230 MARTIN ROAD

Title: 100471 - 230 Martin Road Badgerys Creek
Prepared by: Han Xu
Revision: C

RESPONSE TO SDRP RECOMMENDATIONS

Image: Site plan of pedestrian pathway.

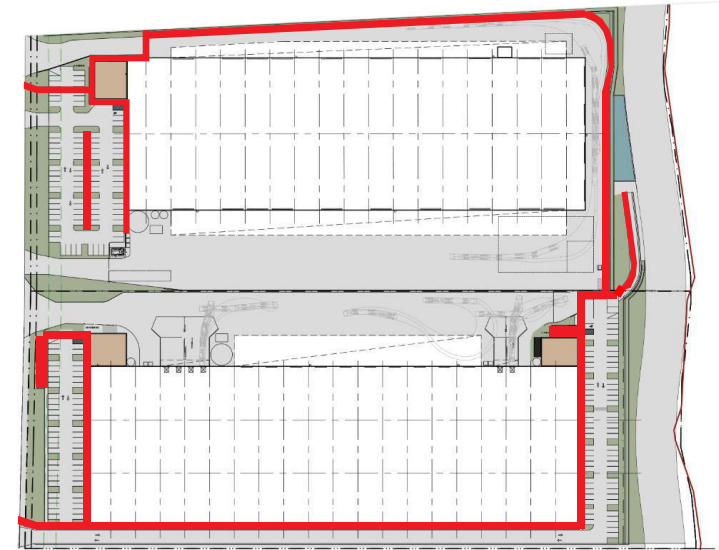
4a) Provide separated pedestrian access paths connecting the Martin Road footpath with the offices to avoid conflicts between cars and pedestrians.

Modifying the slope of the carpark to achieve a lower gradient would necessitate raising the lots significantly to attain level/flush access at the office buildings. This adjustment would result in increased retaining wall heights, creating an unbalanced site and further visual and physical barriers to Wianamatta-South Creek from Martin Road.

The design proposes a two-tiers high retaining walls, which is lower than the maximum permitted three-tiers wall as specified by Development Control Plan (DCP).

Image: Office 1 Circulation. Illustrating how the lunch area connects directly to the outdoor space, providing easy and immediate access for employees.

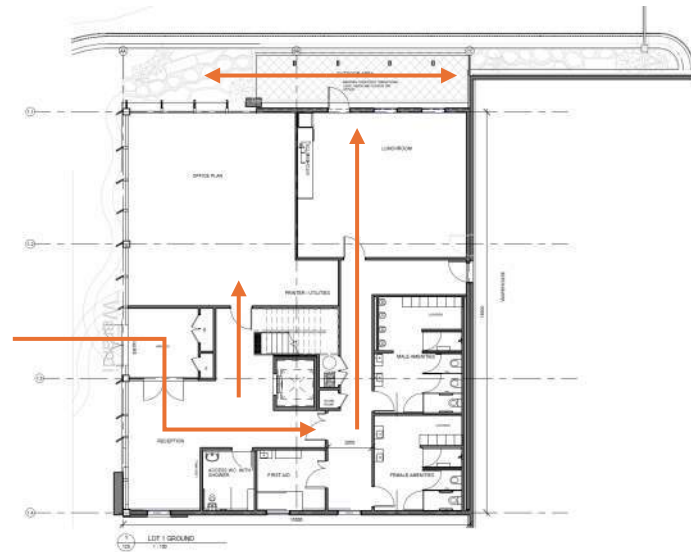
6) The lack of staff amenity has not yet been addressed. External staff recreation spaces should link directly from the office areas, connect with the natural environment, and provide outlook, passive recreation, and opportunity for social interaction. The health and wellbeing of employees will benefit the business operation.

- **Green Spaces**: The design includes landscaped areas with native plants and greenery around the office and recreation spaces, creating a natural and relaxing environment for employees.
- **Outdoor Views**: Large windows and strategically placed seating areas provide views of the natural surroundings, enhancing the overall workplace atmosphere and reducing stress.

- **Covered Outdoor Spaces**: For employees working in industrial environments, covered outdoor spaces provide protection from the elements while allowing them to take breaks outside.

- **Medicinal and Edible Native Plants**: Confirmed through consultation with Community, these plants will be included to provide educational and health benefits.

- **Connection to Country**: Facilitated through signage that educates about the medicinal and edible uses of native plants, fostering a deeper connection to the local culture and environment.
